ADDENDUM NO. 2

Issued by: Sacramento City Unified School District

Project: 0495-417, Will C. Wood and Abraham Lincoln Irrigation Improvements

CVR

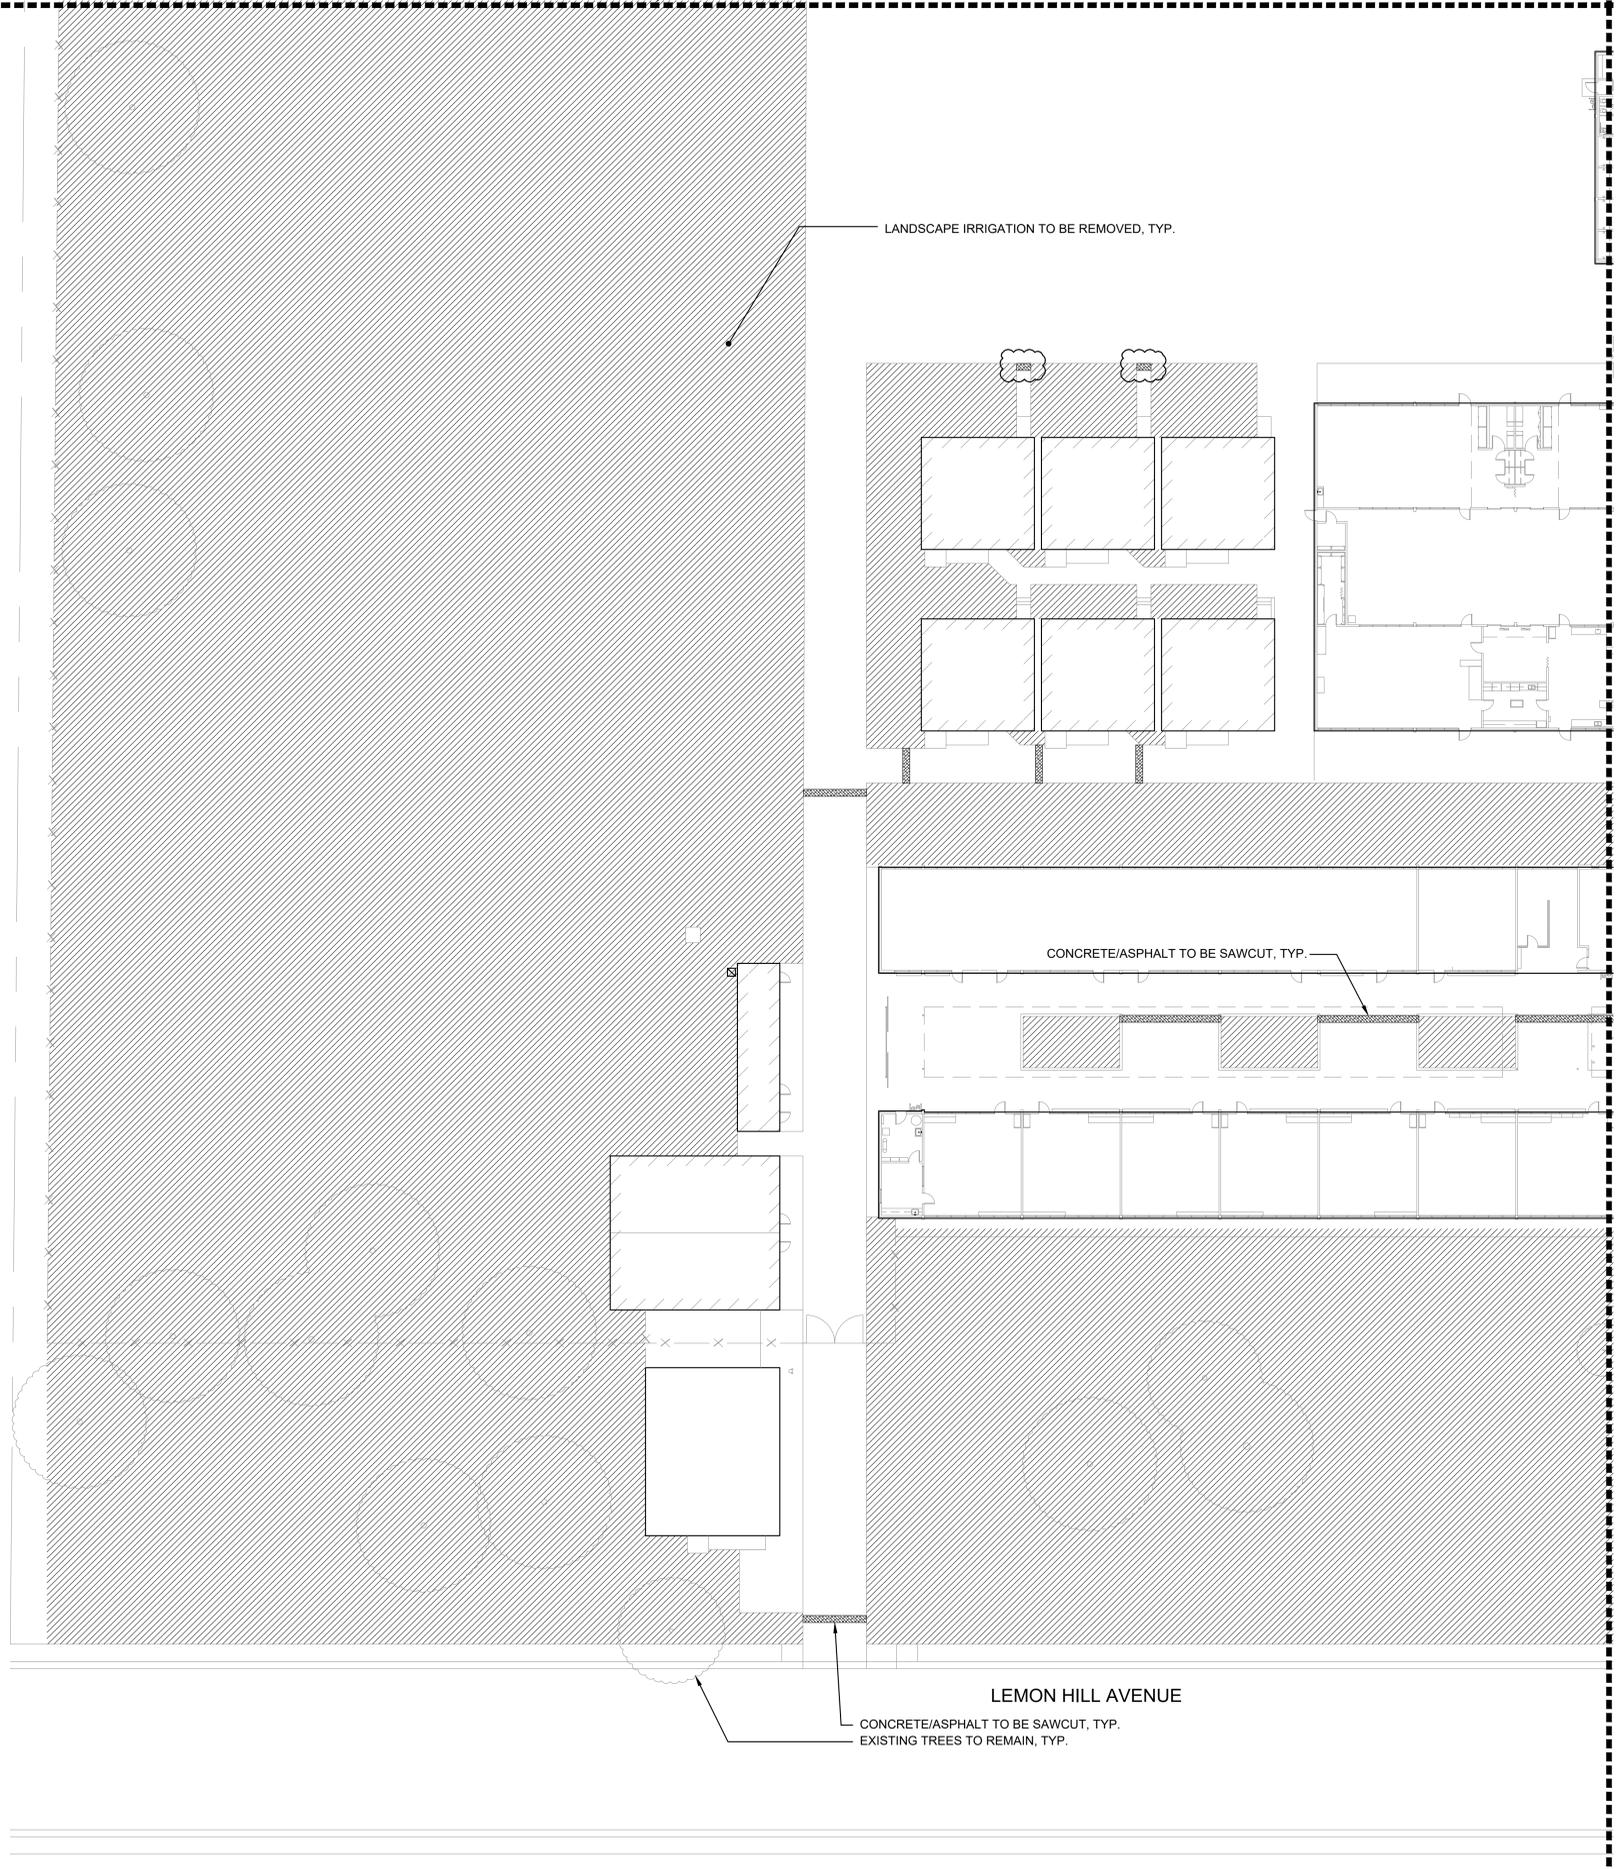
1. CVR
 - a. Deleted Project Note #7
2. L1.1A, L1.2A, L1.4A
 - a. Added additional sawcut locations for new mainline/laterals shown.
3. L2.1A, L2.2A
 - a. Added station D17 and irrigation heads adjacent to the building.
 - b. Added station D18 and irrigation heads adjacent to the building
 - c. Updated station D8 and connected planter heads.
4. L1.2B
 - a. Added additional sawcut locations for new mainline/laterals shown.
 - b. Added note to excavate utility yard pad.

2 TYPICAL VALVE BOX LAYOUT - IN LAWN

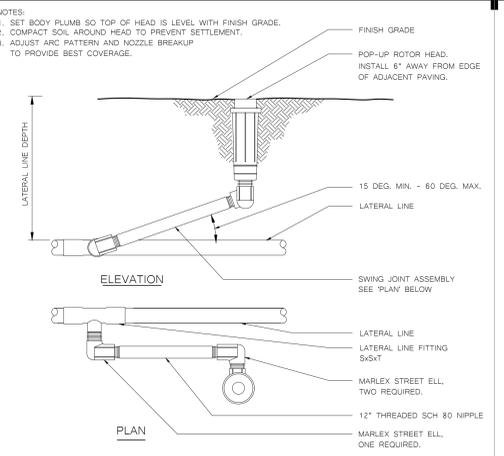
5. L2.2B
 - a. Added note to re-use existing pipe as sleeve for station 27.
 - b. Relocated station 28 valve and rerouted lateral line.
6. L3.1
 - a. Revised detail 2.
7. L3.2
 - a. Revised detail 2 to include rebar and reference detail L3.1-2.
